Clarence Colliery
918 Panel
Extraction Plan
Main Report
VOLUME ONE

April 2026

| DOCUMENT CONTROL / TITLE BLOCK | | |
|------------------------------------|--|--|
| | Version: | Final – 24 April 2026 |

Figure 1: Groundwater Monitoring Network in the vicinity of 918 Panel (excerpt of Figure 3.10b of JBS&G (2026))

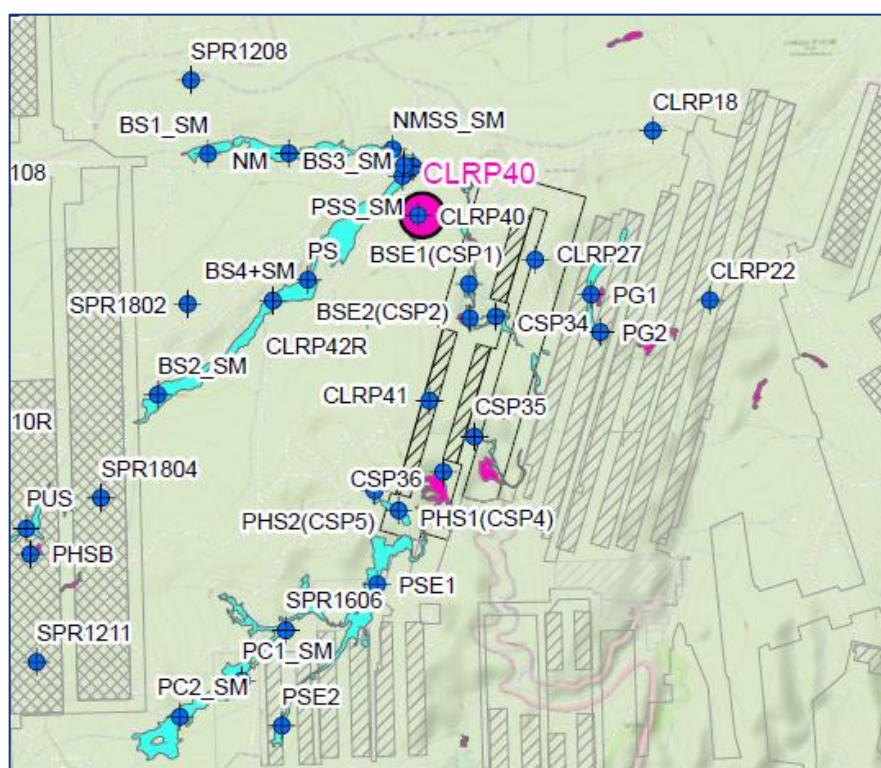
Issue NSW DCCEEW 5.04) “There are no piezometers directly monitoring the Buralow aquifers that feed the swamps in the Bungleboori and Paddys Creek catchments² (including Paddy’s Creek Hanging Swamp).

From **Figure 1**, there are multiple monitoring piezometers in the vicinity of 918 Panel. These exist in both the Burrellow Formation and the Banks Wall Sandstone.

Figure 3: Groundwater Hydrographs (Calibration Period) (after Figure 4.28a of JBS&G (2026))

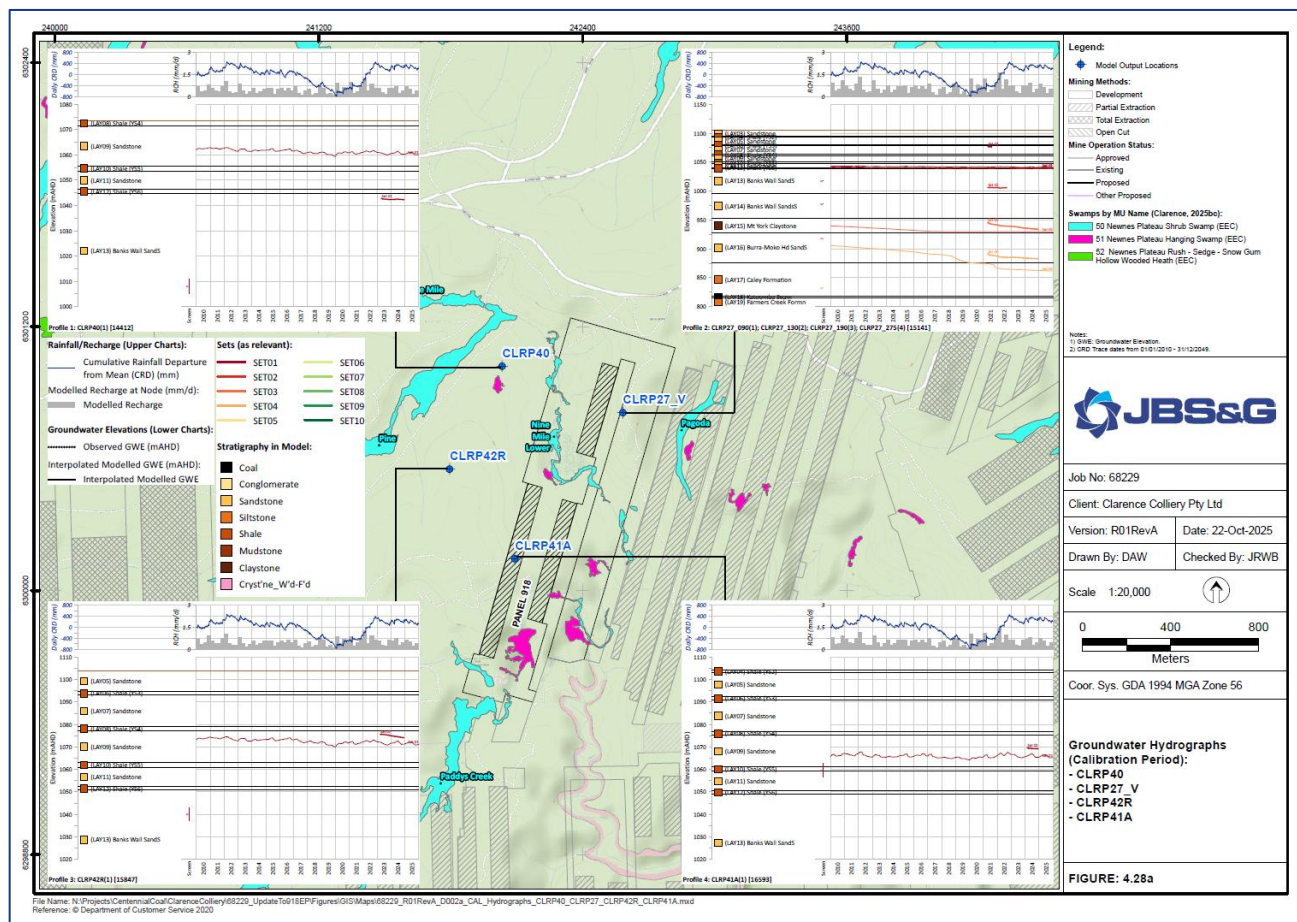
- *Based on JSB&G’s Figure 4.28, the model appears to overestimate observed aquifer levels with discrepancies in modelled and observed levels at times being >50m. Since other areas of the extraction plan suggest that the Burrellow Formation is ~50m thick in this area, this could potentially mean that the modelled water level could either be in the Burrellow formation or outside of the Burrellow formation. As such it provides very limited value in assessing the potential (modelled) impact of the proposed mining at Clarence on aquifers within the Burrellow Formation (or elsewhere in the modelling domain).”*

Figure 4.28a of JBS&G (2026) presents comparison of observed and modelled groundwater elevation in CLRP27R and CLRP40 as well as others. Figure 4.28a is replicated as **Figure 3**, below, for the purpose of reference.

As was responded to at the time (JBS&G, 2024), and remains the case in JBS&G (2026), Figure 4.25 in Section 4.12.4.3 of JBS&G (2026) (equivalent to Figure 4.28 of JBS&G (2023)) presents three groups of piezometers: being Swamp Standpipe Piezometers, Shallow or Regional Standpipe Piezometers and Vibrating Wire Piezometers.

Observed versus Modelled Heads (mAHD) is closely matched for swamp piezometers. As explained in JBS&G (2026) (and in JBS&G (2023), at the time), for vibrating wire piezometers, “From Figure 4.26, the distribution of weighted residual for Group 3 (Vibrating Wire Piezometers) is more negative than positive. As discussed in JBS&G (2025ab), and presented further below, this is due to initiation of decline in groundwater elevation at depth (in response to mine dewatering) earlier than observed. This issue is not significant, however.”
